55 Fitzroy Park  
N6 6JA

Basement Impact Assessment  
Audit

For  
London Borough of Camden

Project Number: 12985-19  
Revision: F2

Ground Floor Plan of Plot 3 showing the recessed location of the lower ground floor excavation (Blue line)

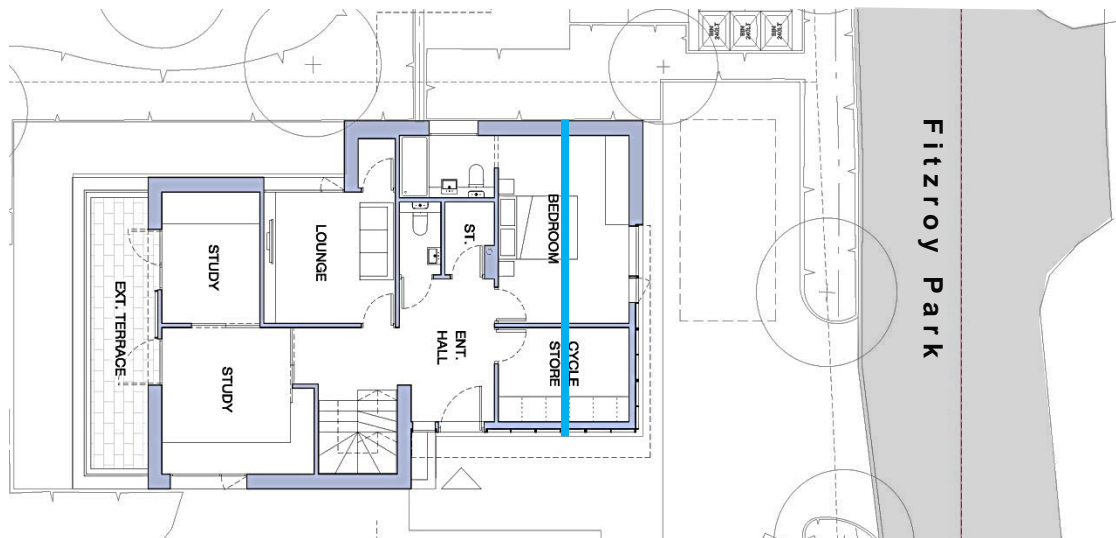
The proposed lower ground floor excavation will be some 7m back from Fitzroy Park, recessed below the ground floor.

Sketch section for Plot 3

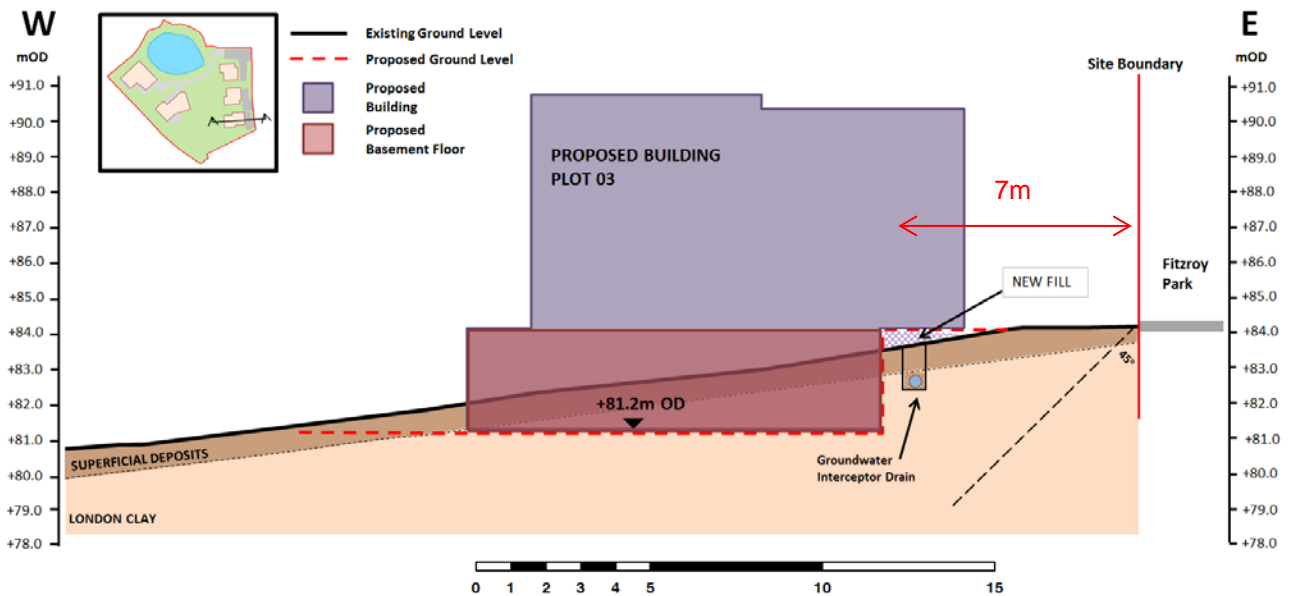
The groundwater interceptor drain will be installed on the London Clay at around 1m below the present ground surface. As can be seen the arrangement, presented to scale on the section below, will result in the excavations taking place sufficiently far away from the carriageway not to infringe on a 45° theoretical line of support to the road.

Therefore, no stability impact is predicted on the Fitzroy Park carriageway.

Proposed section sketch for Plot 1

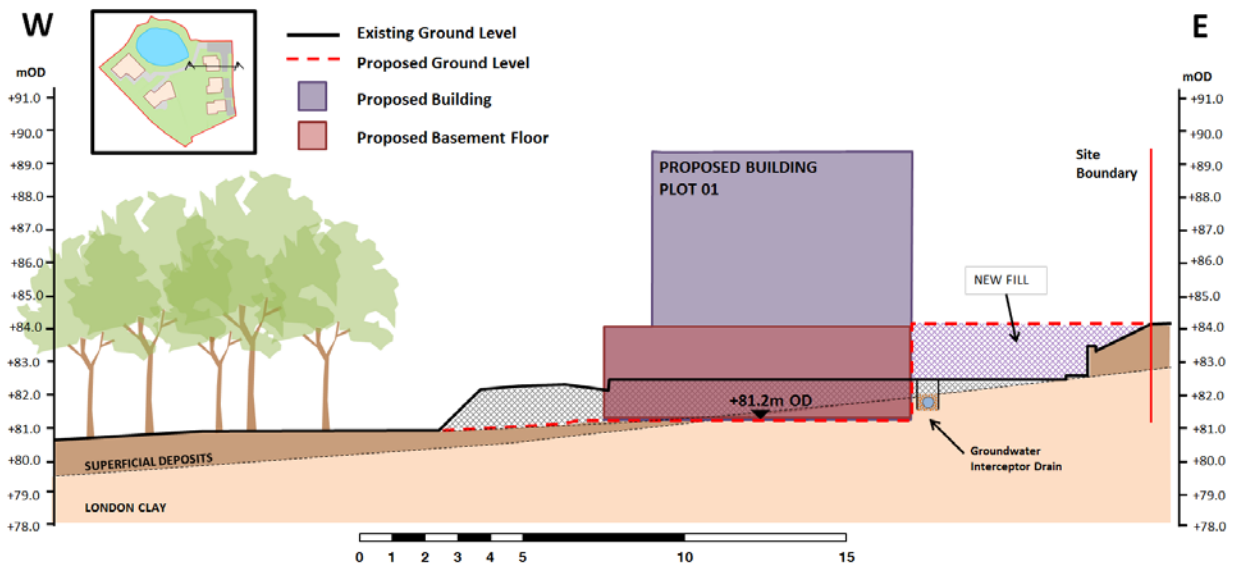
The proposed excavations at Plots 1 and 2 will take place further away from Fitzroy Park than the Plot 3 situation and hence no impact on the carriageway is also predicted here.
